## Gross Weight Increase to 1370lb (621kg)

Classification:	Optional
Applicability:	All pre XS Europa aircraft
Compliance:	N/A

Fig 1. Section through port side spar pin bush area.

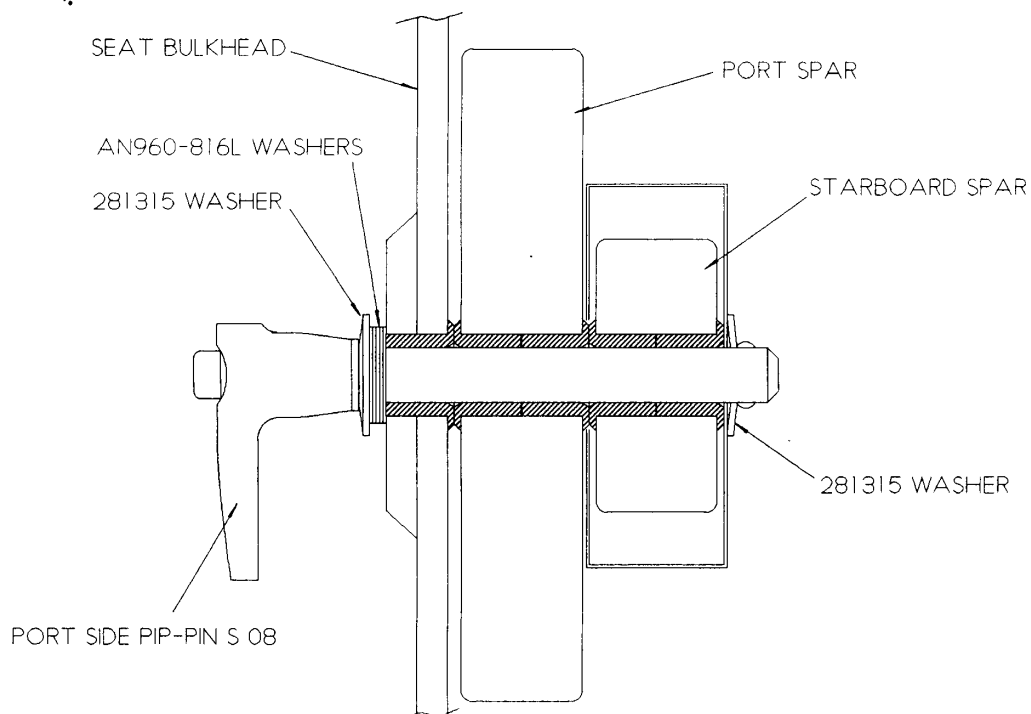
To strengthen the rigging socket hole against which the pip-pin will react, a hardened steel washer is to be bonded in place. A sectional view through the spar at the pip-pin location is shown in figure 1.

Fig 2. Section through starboard side spar pin area.

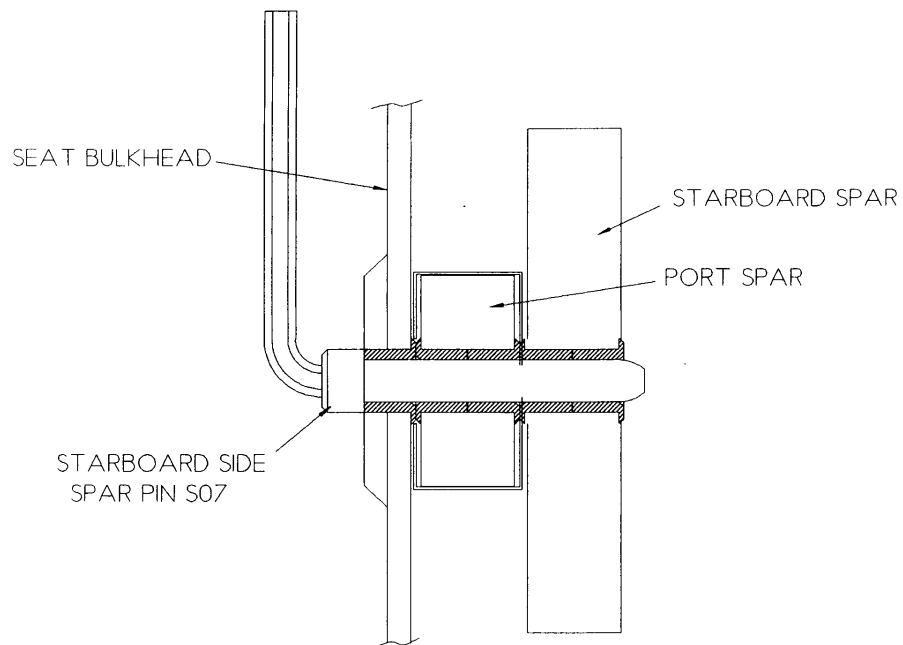
The starboard spar pin SO7 will require the threaded end cutting off so that it measures 85mm (3-3/8") from under the head. Round off the end to enable easy location. A sectional view through the spar at the starboard pin location is shown in figure 2.

Fig 3. Starboard spar pin safety latch.

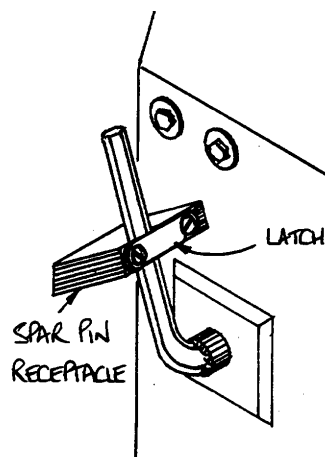
The receptacle of the starboard spar pin safety latch will require its slot being made slightly bigger to accommodate the spar pin's handle. Check that the latch still closes over the handle to lock it in place. See figure 3.

Fig 4. Detail of port side aileron quick connect bellcrank.

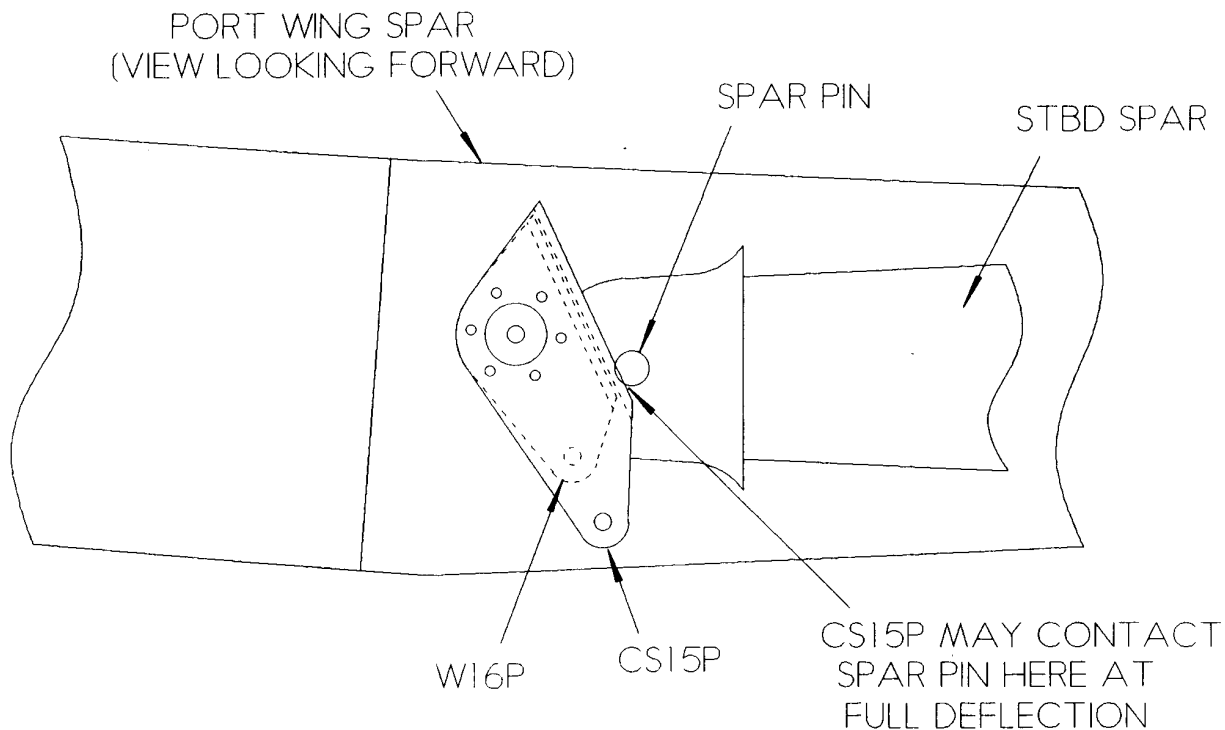
At full aileron deflection (roll to starboard) there is the possibility that a corner of the aileron quick connect bellcrank CS15P, which is mounted in the fuselage, may contact the "!" pip-pin. With the aircraft rigged and the aileron controls correctly adjusted, the W16P bellcrank will not contact the pin. See figure 4 and confirm this on the aircraft.

Fig 5. Cut-out as required in CS15P.

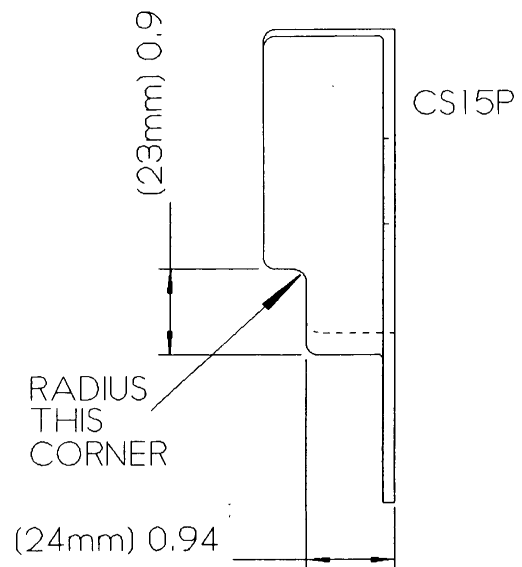
To avoid contact with the pin, the corner of CS15P should be removed as shown in figure 5. Ensure that the inner corner is radiused as shown.

On installation, check that there is clearance between the spar pin and CS15P, making any small adjustment as necessary.

Fig 6. Exploded view of W26 wing rear pin socket assembly

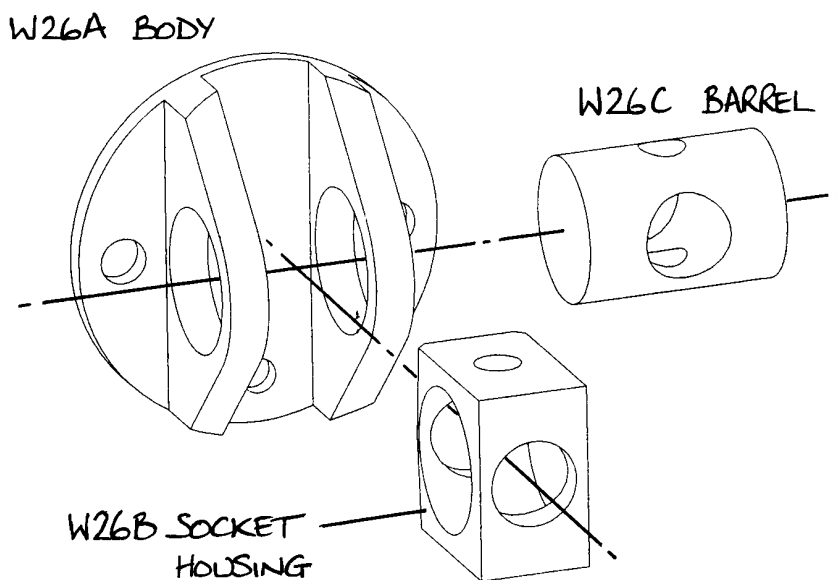
Each rear socket is an assembly of a W26A, W26B and W26C. The W26A is the main body and is oriented with the smaller hole between the lugs at the bottom. W26B is the socket housing which slots between the two lugs of the body with the double chamfered face innermost. These chamfers allow the housing to rock a limited amount. Holding W26A and W26B together is W26C, the barrel. See figure 6.

*Fig 7. Plywood mounting pad.*

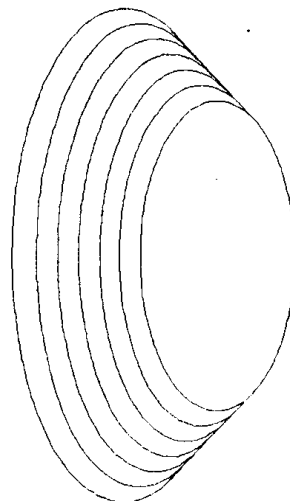
The new W26 socket assembly is 2.5 mm (0.1") deeper than the original socket so this amount will be required to be removed from the existing mounting pad. Due to the revised shape of the socket's mounting face it may be prudent to remove the existing mounting pad entirely and make a new one in a conical shape as shown in figure 7.

If the gap is greater than 5 mm (3/16") up to a maximum of 13 mm (1/2"), make a mounting pad from good quality plywood to reduce the gap to approximately 2 mm (3/32"). The outer face of the mounting pad should be at least the same size as the socket and have chamfered edges of 45° to 60° see figure 7.

Fig 8. Top and sectional view of tie-bar and socket (port side).

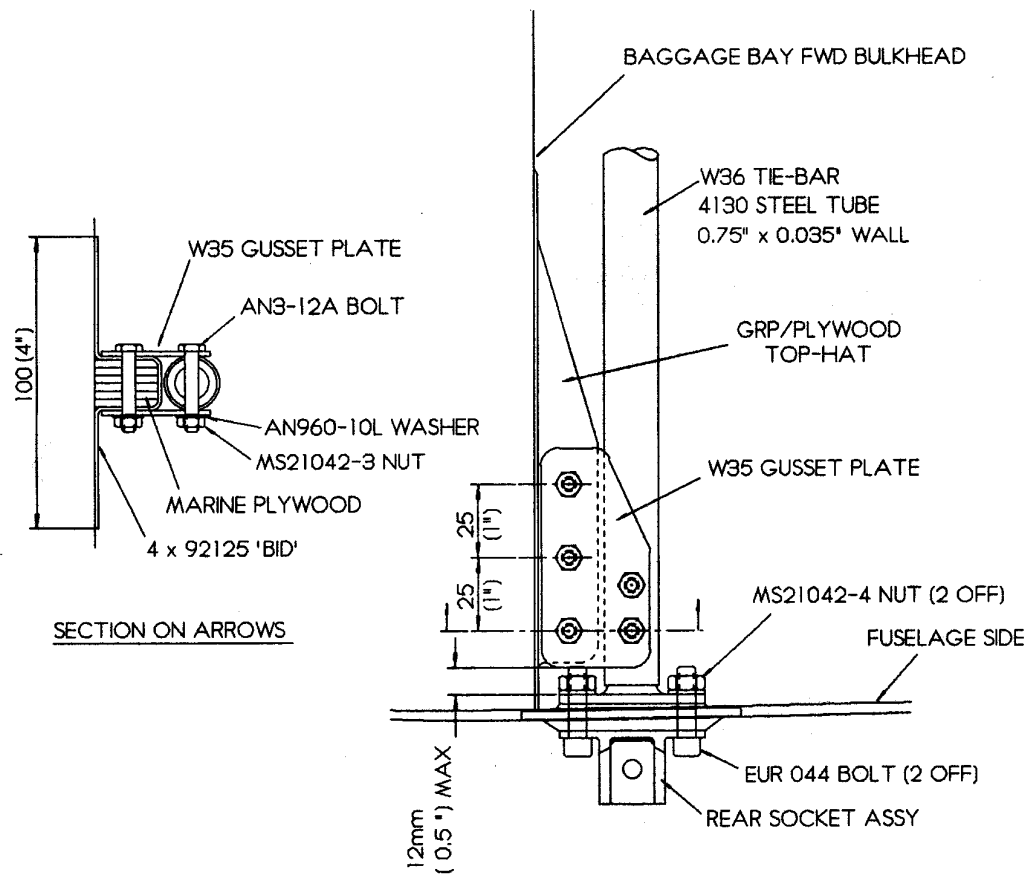
As the trailing edge lift pin also acts to contain drag loads and the forward component of lift which is produced at high angles of attack, a tie-bar will be fitted across the fuselage to react these loads. A general arrangement of the tie-bar assembly and associated parts is shown in figure 8.

In addition to reacting the tensile/compressive loads it is necessary to provide sideways stiffness for asymmetric loads. This is done via two plywood blocks laminated onto the baggage bay front bulkhead, which are connected to the tie-bar by means of gusset plates. Refer to figure 8.

*Fig 9. Plywood block for gusset plates.*

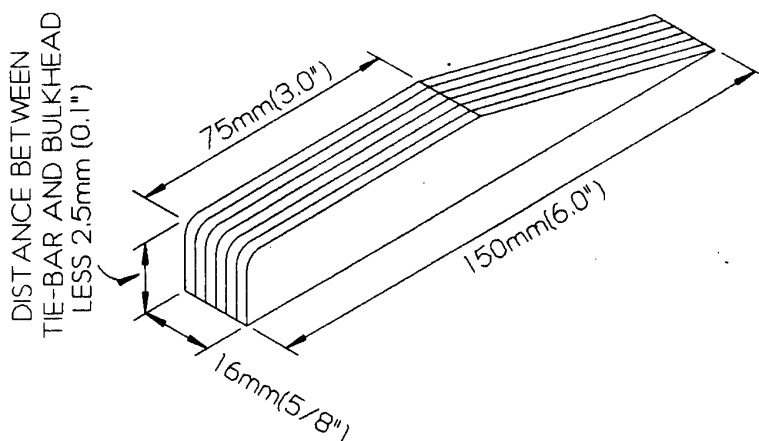
Make up the two plywood blocks according to figure 9. As each aircraft is bound to be slightly different, the width of the blocks must be determined by measurement.

Fig 10. Section through baggage bay centre tunnel.

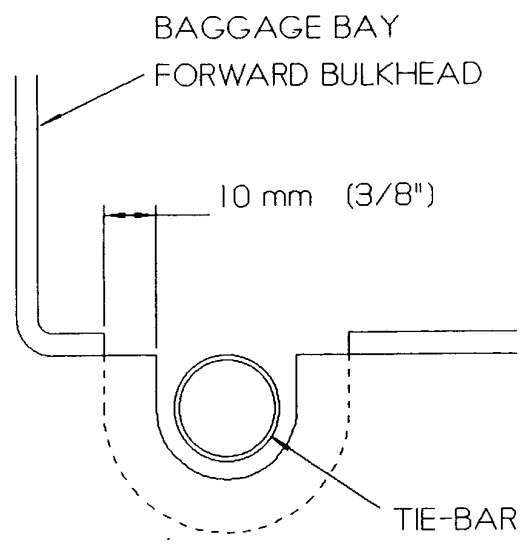
Prepare each side of the slot in the central tunnel of the cockpit module for a glass fibre layup by removing the upper skin and foam to expose about 10 mm (3/8") of the lower skin. See sectional diagram in figure 10.

Fig 11. Section through tunnel detailing layup sequence.

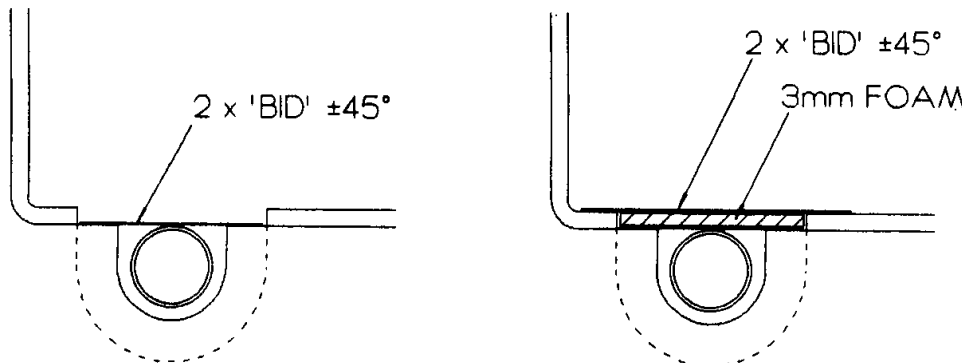
Layup 2 plies of 'bid' at  $\pm 45^\circ$  on plastic sheeting at least 30 cm x 20 cm (12" x 8"). Cut a strip to fit into the slot and lay it to join the inner skins together. Drape it over the tie-bar, cutting it to allow it to go around the tie-bar at the sides. See figure 11.

Fig 12. Former position on spar.

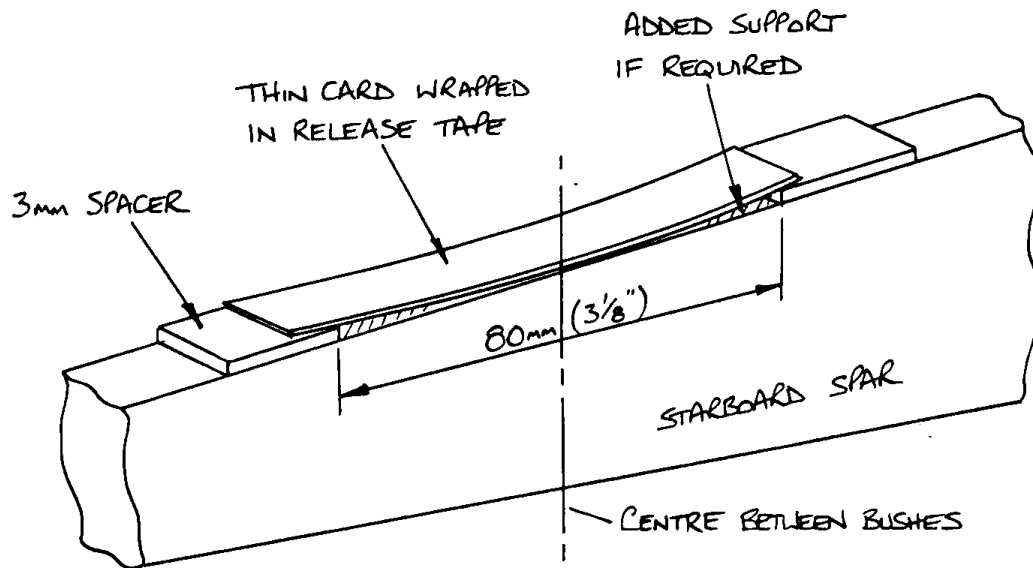
Using two 3 mm thick spacers placed on the spar as shown in figure 12, position the card former between them so that it curves and, using the release tape, attach it to the spar. Wrap the release tape, all around the spar trying not to distort the curved shape of the card. It might be wise to support the card in various places underneath so you don't lose the curve.

Fig 13. Bracket plies in position on port spar.

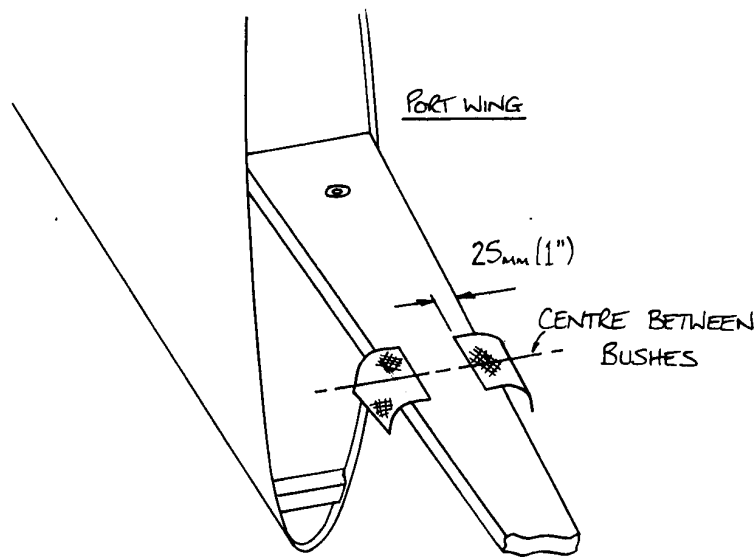
Position the bracket layups onto the centre of the port spar, lapping just 25 mm (1") onto the spars rear face, one at the upper edge, the other at the lower edge. See figure 13. For now, leave the bracket's pieces hanging down.

Fig 14. Brackets wrapped around starboard spar.

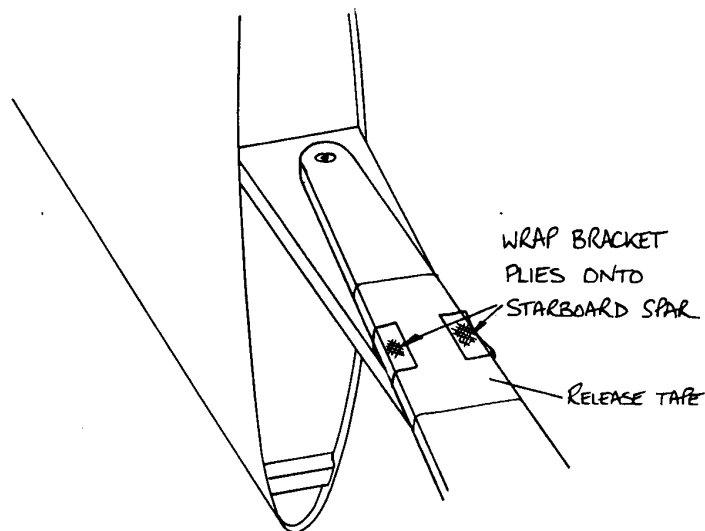
With the spars together, wrap the bracket layups around the starboard spar. See figure 14.

Fig 15. Spar strap trimmed to size

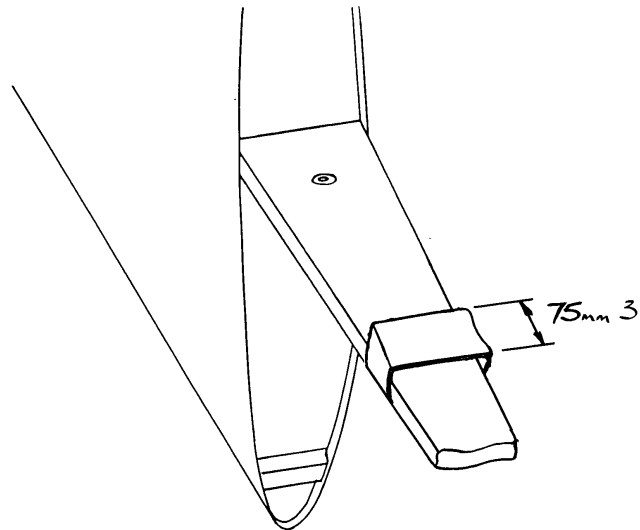
After cure, remove the spar pins and separate the spars. Trim the edges of the strap to remove sharp edges, adjusting the strap's width to no less than 75 mm (3"). See figure 15.
